SERVICE BULLETIN No.1098

COACH MODEL	: All coaches equipped with Detroit Diesel engine
BULLETIN TYPE	: Service Information
MANUAL & SECTION	: Not applicable
PARTS BOOK REVISION	: No
DATE	: February 6th, 2002
SUBJECT	: Detroit Diesel accessory drive specification change
TERMS & CONDITIONS	: No claims will be accepted with reference to this Bulletin.

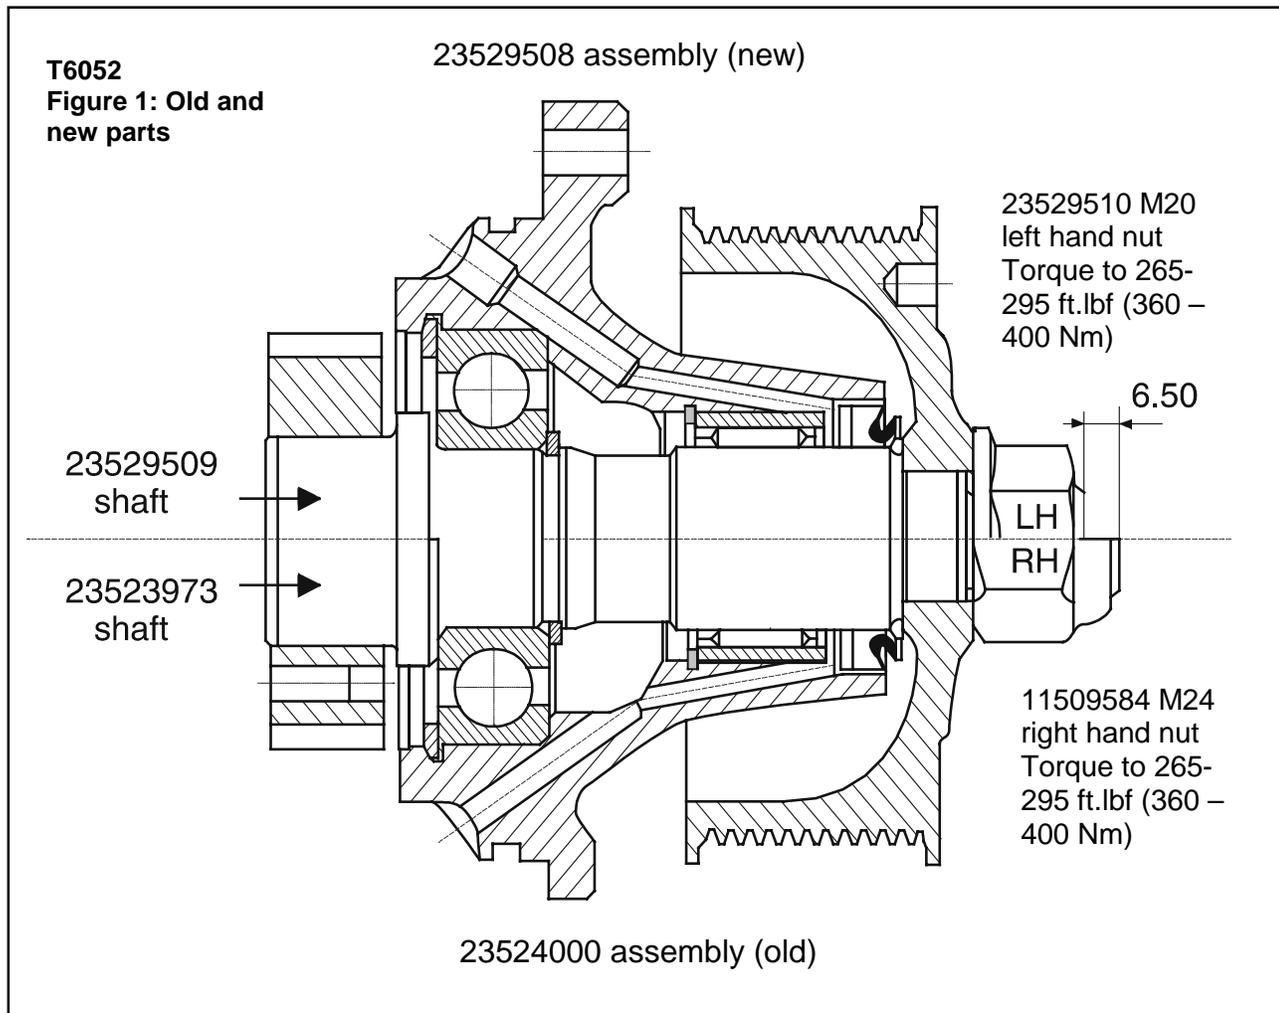
Detroit Diesel have made a change to the accessory drive assembly to increase the bearing length and force feed oil to the bearing. An improved seal was also included in the change.

As a result, the shaft length of the pulley assembly increased by 1/4 inch (6.5 mm). This increase in length caused clearance problems with the cooling fan belt installation (see Figure 2).

As a *permanent* countermeasure, Detroit Diesel have now introduced a new accessory drive assembly with a shortened shaft to provide the required clearance, and a left hand threaded M20 nut to secure the pulley. This feature avoids the necessity of a locking feature on the nut, as opposed to the right hand threaded nut on the original shaft, since the pulley will turn in the direction to cause the nut to tighten.

Attached to this Bulletin is a drawing showing both the old and the new design.

New parts

Part No.	Description
DD #23529508	Accessory drive assembly w/ ¼ inch shorter shaft
DD #23529509	Shaft for DD #23529508, M20 left hand thread
DD #23529510	Nut, M20, left hand thread

Old parts

Part No.	Description
DD #23524000	Accessory drive assembly w/ lengthened shaft
DD #23523973	Shaft for DD #23524000, M24 right hand thread
DD #11509584	Self-locking nut, M24 right hand thread

Figure 2: DD2352400 Assembly clearance problems

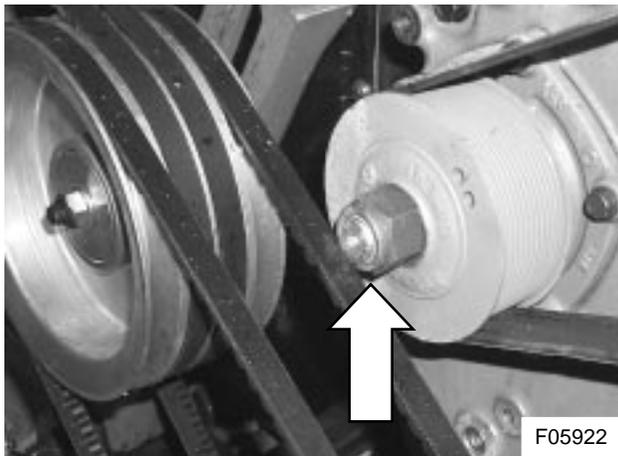
To provide proper clearance between accessory drive assembly #23524000 (see Figure 2) and the cooling fan drive belts, shaft #23523973 needs to be shortened by ¼ inch. Proceed as follows:

- 1) Using an air impact wrench, undo and remove the OEM fitted long self-locking nut (see Figure 2) securing the accessory drive pulley to the shaft.
- 2) With a suitable tool, lift the multi-V belt tensioner and remove the drive belt (see Figure 3). Take note of the routing and the direction of travel of the belt.

Figure 5: Shaft flush with the nut

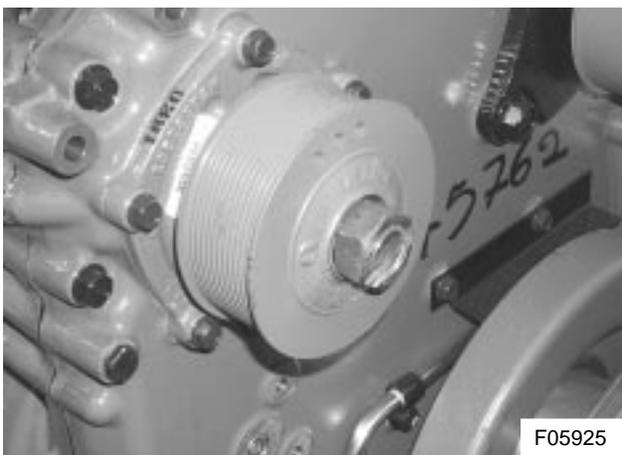
- 3) Run a M24x3 nut VH 660204001 up the threaded part of the shaft until it is flush with the pulley. Secure hand tight.
- 4) With a hacksaw, and using the nut as a guide, cut-off the protruding threaded part (see Figure 4) so that the shaft is flush with the nut (see Figure 5). Dress with a file.

Figure 12: Torqueing pulley retaining nut

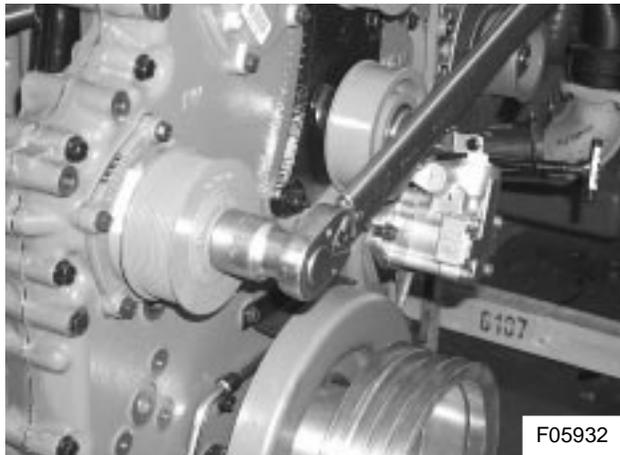
9) Tighten the pulley nut to a torque of 295 ft.lbf (400 Nm) as shown in Figure 12.
